Amphenol PCD

Engineering Change Request		ECR Number	R10516W
Initiator:	Max.Ma	Date:	2026.07.28
Part number description			
Item	K3 Code material part numbers	Drawing/ Doc Number	Version of current related document
1	GEN2 600A CCS1 plug series	All part number drawings, see attached list.	/
2	GEN3 600A CCS1 plug series	All part number drawings, see attached list.	/
3	GEN3 600A NACS plug series	All part number drawings, see attached list.	/
Reason of change: ☐ Customer requirement (list the feasibility analysis of customer specification: _____) ☐ Supplier request (list the PCR number: _____) ☒ Internal improvement ☐ corrective ☐ other Please describe here in detail: 1. Install an SR at the gun-cable joint to prevent over-bending during field use. 2. UL certification has been filed.			
Change level and impact assessment (Please tick in the appropriate position)			
Change level	Change content	Concerned area(Shenzhen, Hermosillo, Chennai)	Whether to notify the customer

Engineering Change Request		ECR Number		R10516W
Initiator:		Max.Ma		Date: 2026.07.28
Part number description				
Item	K3 Code material part numbers	Drawing/ Doc Number	Version of current related document	New Version
1	GEN

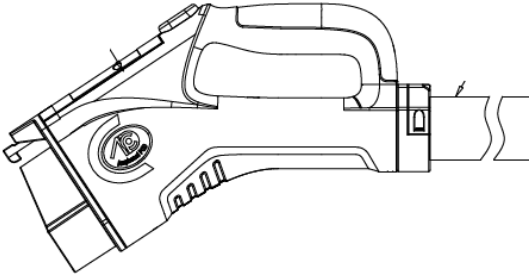
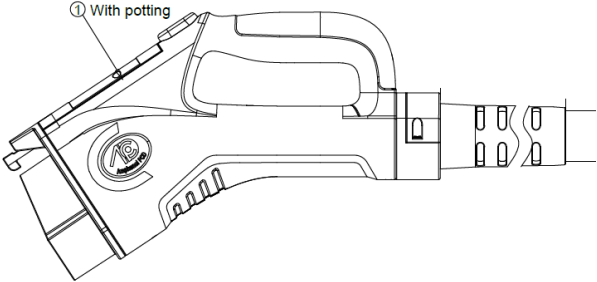
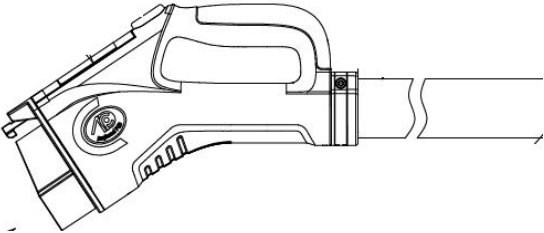
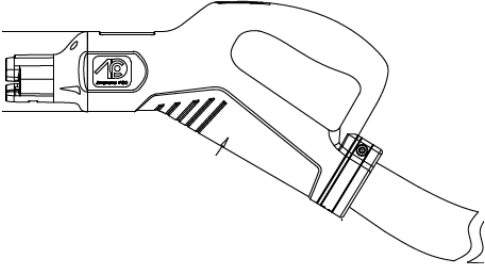
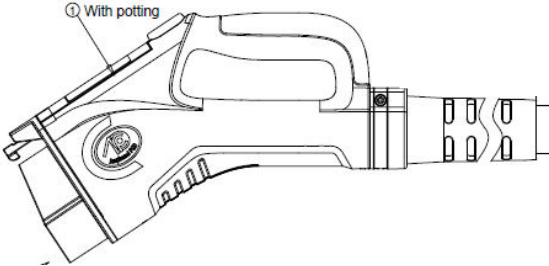
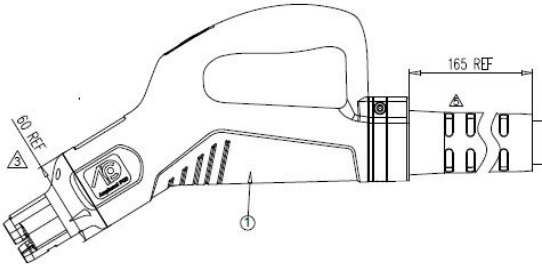
Before change 1.CCS1 : Gen2 Without SR 		After change 1.CCS1 : Gen2 With SR 	
2. CCS1 NACS: Gen3 Without SR  		2. CCS1 NACS: Gen3 With SR  	
Disposition of old materials ☐ Rework ☒ Use as it is ☐ scrap ☐ Other (please describe): _____ ☐ N/A			Expect date to switch to new material <u>2026.09.30</u>
Approval by the supervisor of requester.: <i>Ben</i>		Approval by the head manager of the request dept.: <i>Ching Hung</i>	
Customer approval: ☐ Approved ☐ No approved ☐ Conditional approval (please describe) : Signature: _____ Date: _____			
Remark:

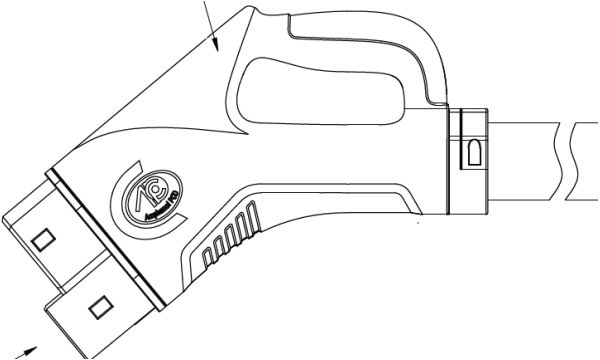
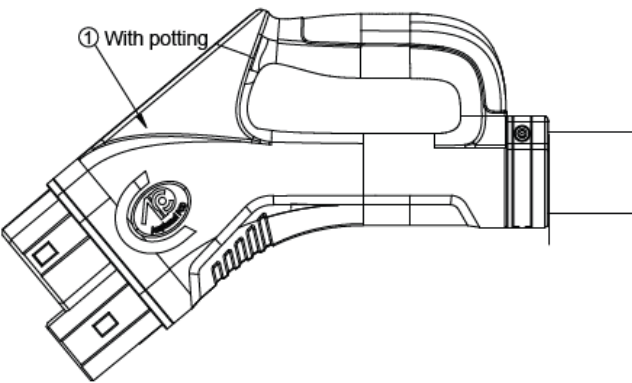
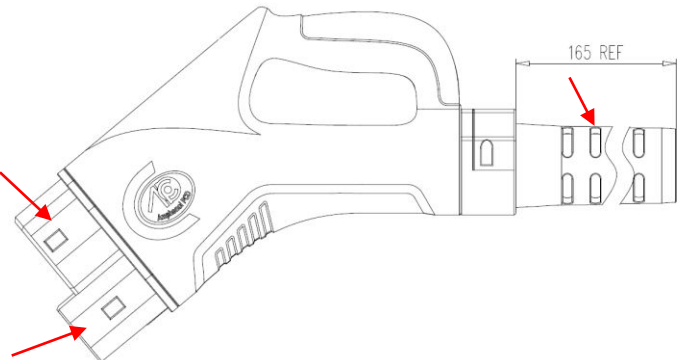
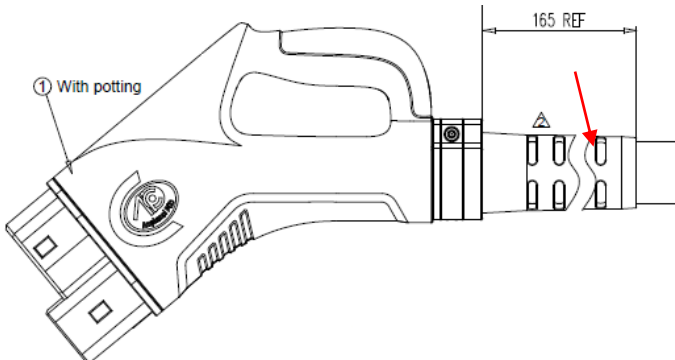
Before change 1. CCS2 : Gen2 Without SR and Rib  2. CCS2: Gen3 Without SR 		After change 1. CCS2 : Gen2 With SR and Rib  2. CCS2: Gen3 With SR 	
Disposition of old materials ☐ Rework ☒ Use as it is ☐ scrap ☐ Other (please describe): _____ ☐ N/A		Expect date to switch to new material <u>2026.09.30</u>	
Approval by the supervisor of requester.: <i>Ben</i>		Approval by the head manager of the request dept.: <i>Cheng Huang</i>	
Customer approval: ☐ Approved ☐ No approved ☐ Conditional approval (please describe) : Signature: _____ Date: _____			
Remark:
